Facilities and Operations Committee Monthly Meeting

RE: North Penn High School BP-2
Change Order Request #23 ASI 01 – Additional Shaft wall

PROJECT: *(name and address)* North Penn High School Renovations Bid Package 2	**CONTRACT INFORMATION:** Contract For: Mechanical Construction Date: 08-14-2026	**ASI INFORMATION:** ASI Number: 01 Date: 01-20-2026
OWNER: *(name and address)* North Penn School District 401 E. Hancock Street Landsdale, PA 19446	**ARCHITECT:** *(name and address)* Hord Coplan Macht, Inc. d/b/a SCHRADERGROUP Studio 555 E. North Lane, Suite 5100 Conshohocken , PA 19428	**CONTRACTOR:** *(name and address)* JBM Mechanical, Inc 3273 Gun Club Road Nazareth, PA 18064

Drawing Title:
SECOND FLOOR REFLECTED CEILING PLAN - AREA A1

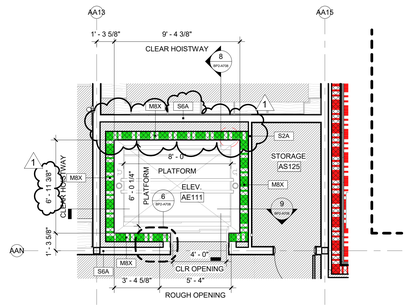
Revisions to Architectural Set:
- Drawing BP2-A122.A1; REPLACE sheet in its entirety (attached). Height of pendant lighting from Second Floor elevation to bottom of fixture provided.
- Drawing BP2-A121.E; CLARIFICATION that 6A WOOD CELING SYSTEM direction in LIBRARY E155 to run short distance to align with lighting.
- Drawing BP2-A708; REPLACE sheet in its entirety (attached). Revise ELEV1 hoistway plan dimensions, layout, and associated head and jamb details.

Drawing Title:
ELEVATOR PLANS & DETAILS

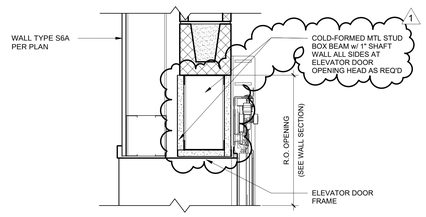
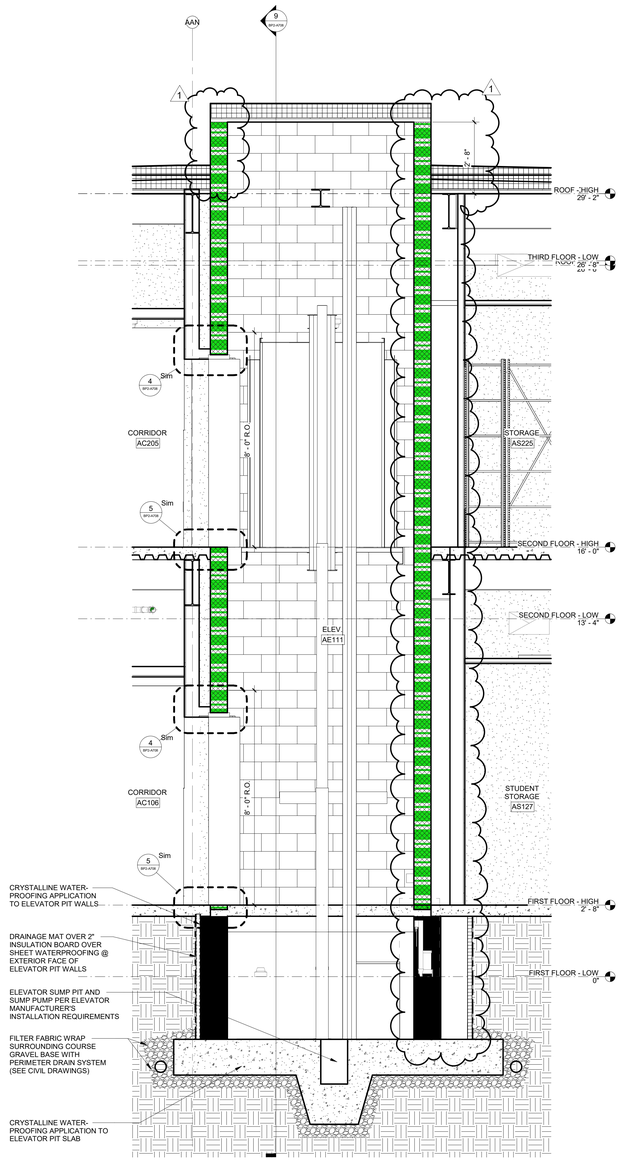
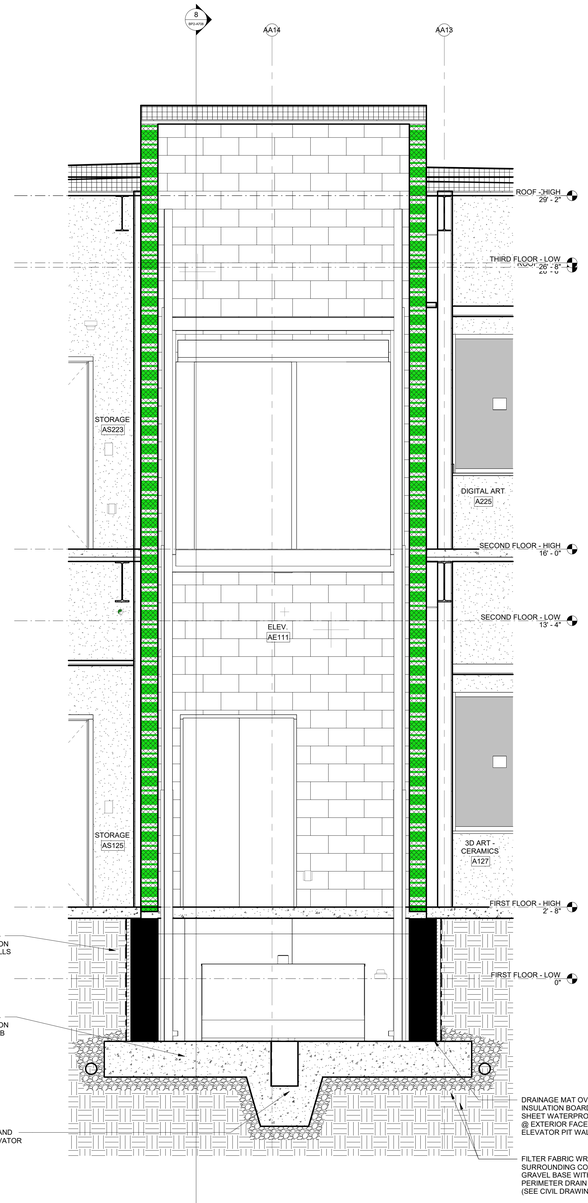
Please see below the costs associated with the changes listed in ASI 01, issued 01-26-2026. This proposal includes providing and installing an added Layer of 1" Shaft Liner to Elevator Doors per Details 4 and 6/BP2-A708.

- **Added Layer of 1" Shaft Liner to Elevator Doors per Details 4 and 6/BP2-A708 of ASI-001.**

Revisions to Structrual Set:
- Modifications to structural steel framing adjacent to elevator shaft shall be made per revised sheet BP2-A708 and reflected on Revise & Resubmit For Record submittals.

Drawing Title:
PARTIAL FIRST FLOOR DIMENSION PLAN - AREA A2

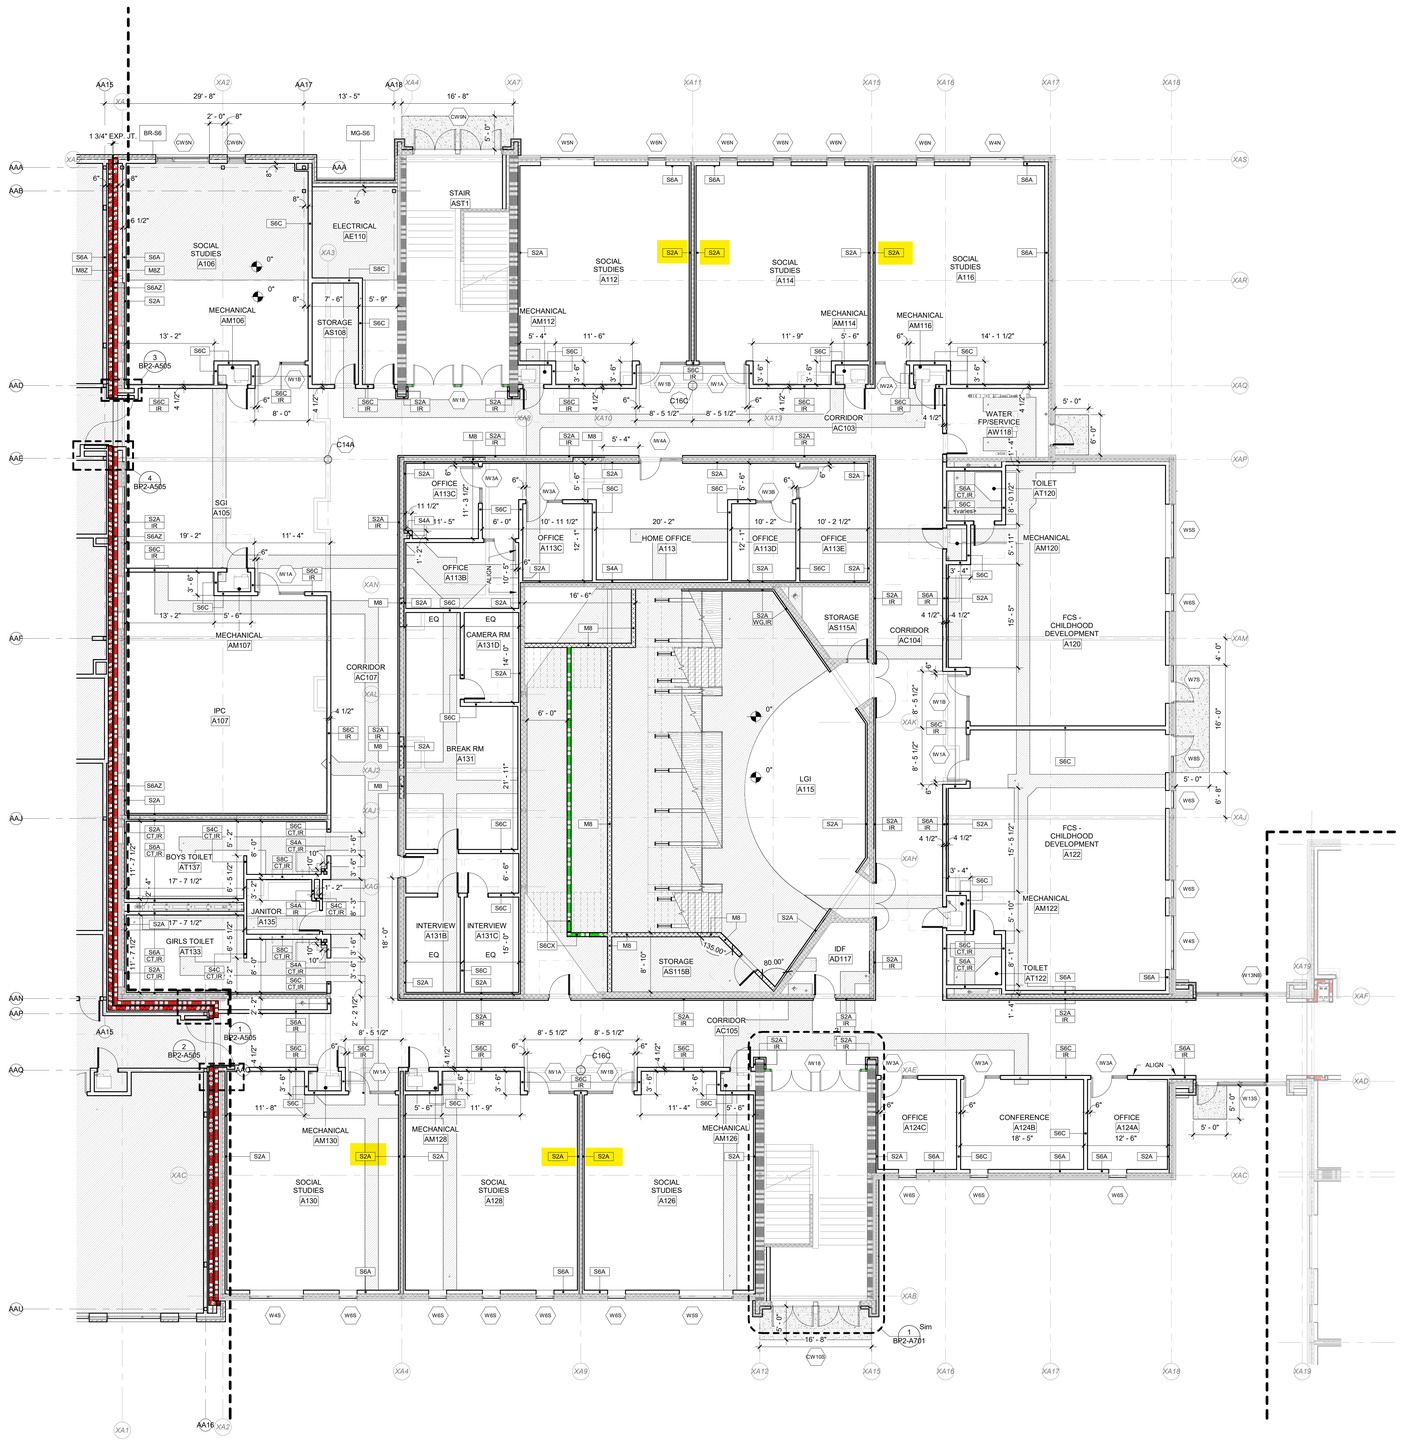
16.01 Architectural BP2-A110 Series Drawings: Revise Classroom AV wall partition type to S4A in lieu of S2A.

1 BP2 - SITE LIGHTING BOLLARD REVISIONS - COURTYARD

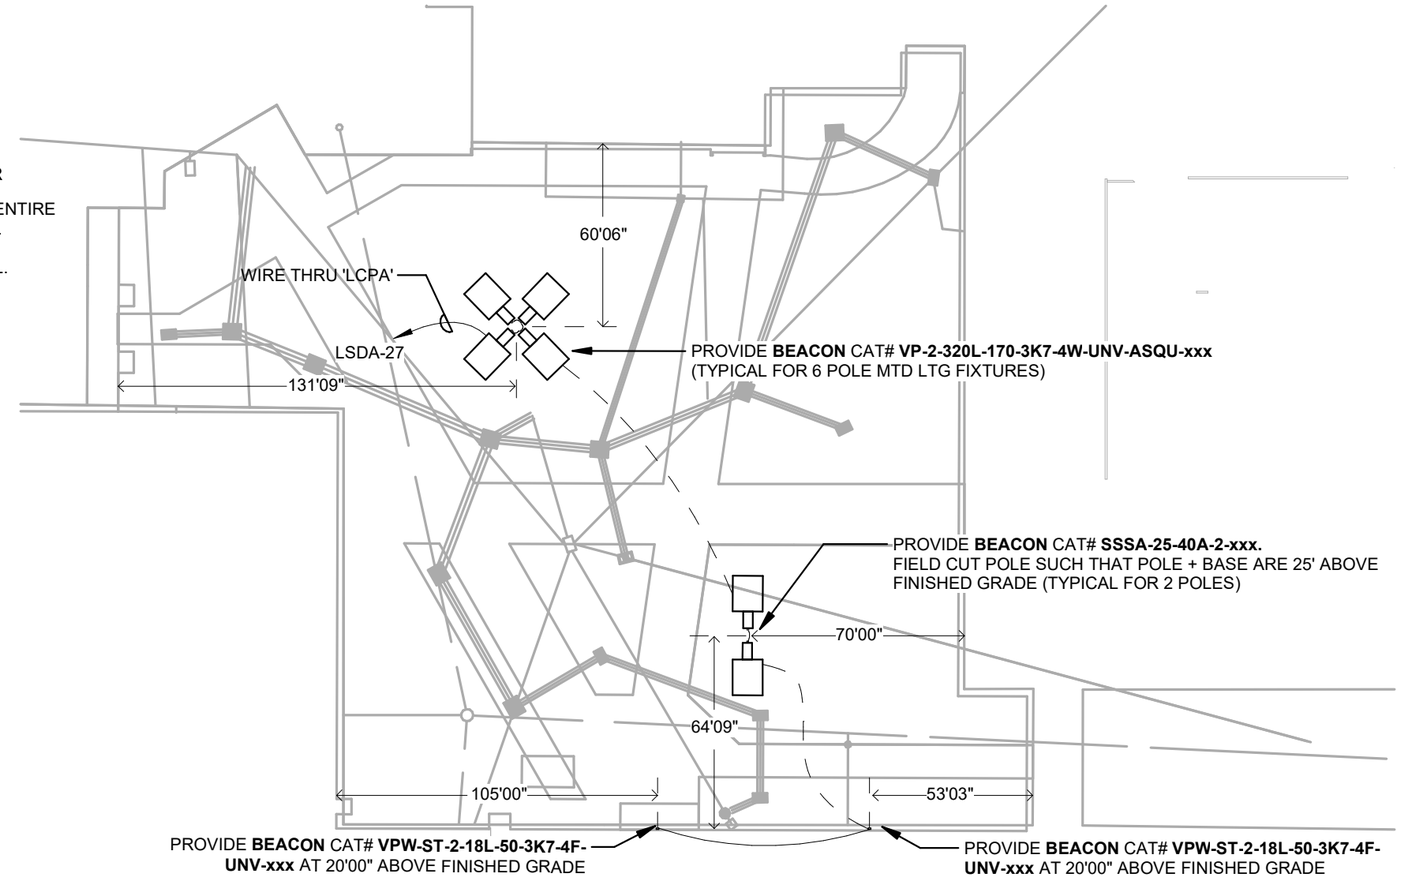
11.04 Sketch BP2-CSKE-9; ADD sketch CSKE-9 dated 06/01/2026.
